Delmore Fast-Track

25/06/2025 – Auckland Council Response

Surface Water

Asset Owner / Specialist Response (BUN60444768 – WAT60444834)

Figure 1: Location of Proposed Temporary Surface Water Diversions, numbered 1 to 12 but with culvert 13 added

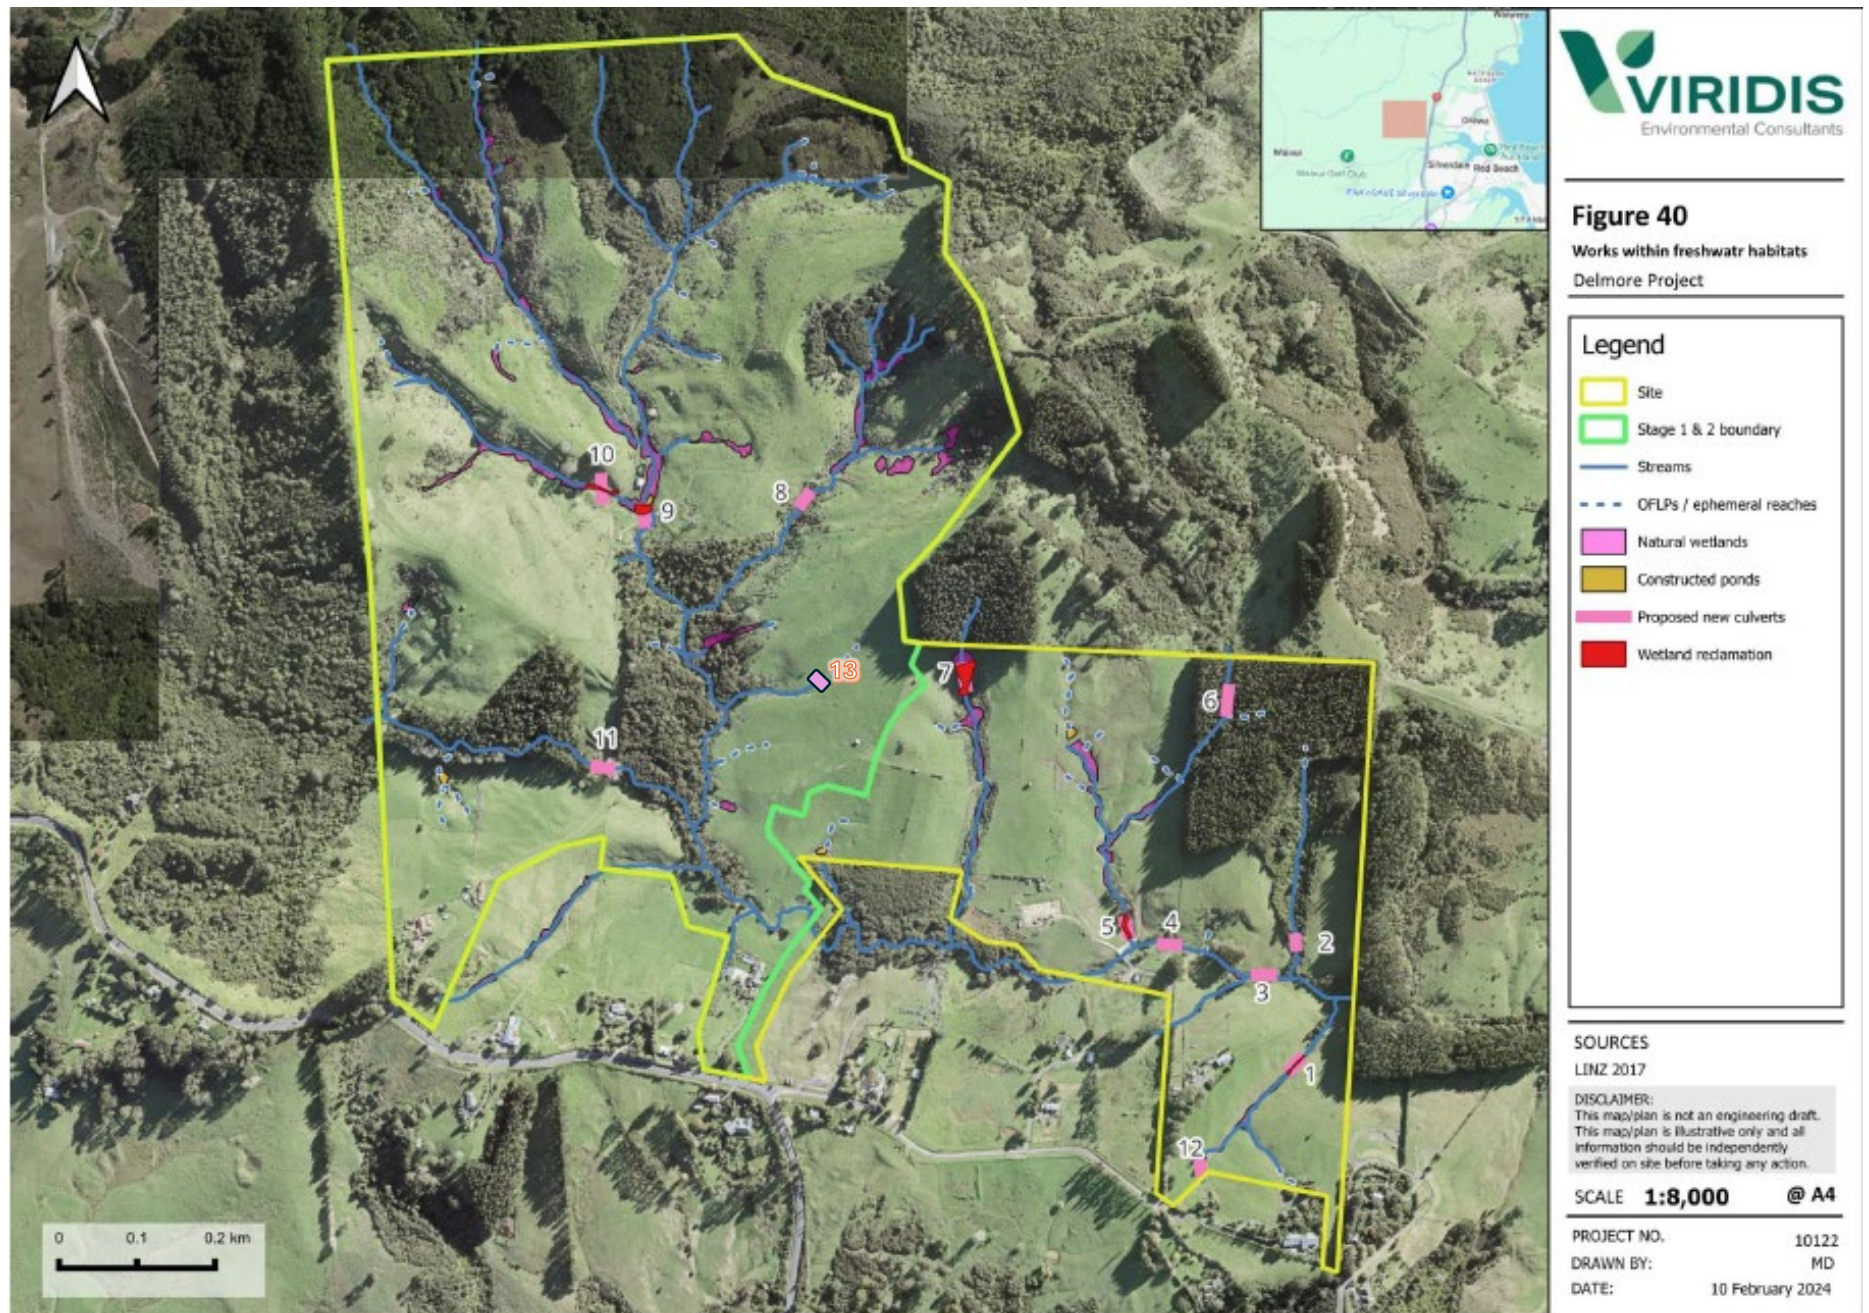
The site was visited on Tuesday 27 May 2025 and Culvert sites 4, 5 and 8 to 11 were visited. Sites downstream of culverts 6 and 7 were also visited. Each site was photographed and relevant aspects recorded. The site locations are presented in Figure 1 attached.
